Access Compliance Report

Public Rights-of-Way

(Curb Ramps)

Intersection ID: 10038783	Main Street: STEELE_CREEK_RD	Cross Street: N/A	Location: NW
ADA ID: 4C28371A82BF	Ramp Type: PerpDiag	Initial Pass/Fail: Fail	Overall Compliance: No
		Severity Score: 25

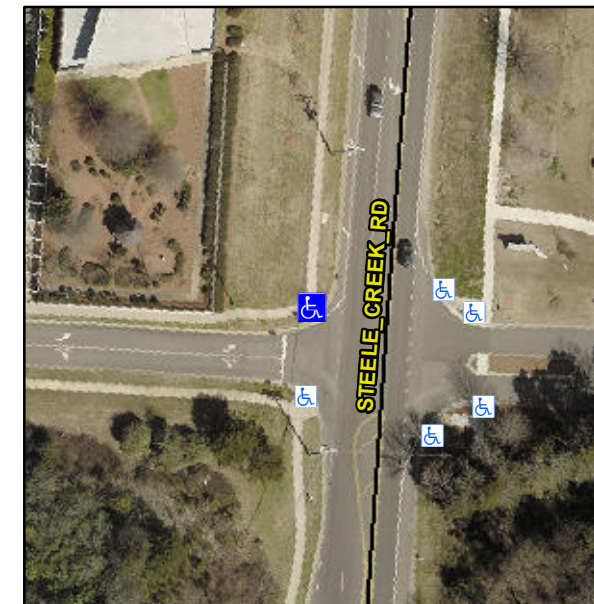
Not Found, R304.2.2, R304.5.3

Compliance	Description	Data	Compliance	Description	Data
N/A	Ramp Length (in)	72.0	No	Ramp Slope (%)	10.3
Yes	Ramp Width (in)	48.0	No	Ramp XSlope (%)	6.2
N/A	Flare Type LT	N/A	N/A	Flare Type RT	N/A
N/A	Flare Slope LT (%)	N/A	N/A	Flare Slope RT (%)	N/A
N/A	Flare Traversable LT?	N/A	N/A	Flare Traversable RT?	N/A
N/A	Landing Length (in)	N/A	N/A	DWS Provided?	N/A
N/A	Landing Width (in)	N/A	N/A	DWS Contrast?	N/A
N/A	Landing Slope (%)	N/A	N/A	DWS Length (in)	N/A
N/A	Landing X Slope (%)	N/A	N/A	DWS Full Width?	N/A
N/A	Landing Curb? (Y/N)	N/A	N/A	DWS Offset (in)	N/A
N/A	Shared Landing?	N/A			
N/A	Gutter Ponding?	N/A	N/A	Gutter Slope (%)	N/A
N/A	Gutter Lip Ht (in)	N/A	N/A	Gutter X Slope (%)	N/A
N/A	Painted X Walk1?	No	N/A	Painted X Walk2?	No
	X Walk 1 Direction	To S		X Walk 2 Direction	To E
N/A	X Walk 1 Width (in)	N/A	N/A	X Walk 2 Width (in)	N/A
	X Walk 1 Slope (%)	3.2		X Walk 2 Slope (%)	3.5
	X Walk 1 X Slope (%)	2.5		X Walk 2 X Slope (%)	1.5

Remove & Replace Curb Ramp With Two New Directional Ramps or Equivalent.
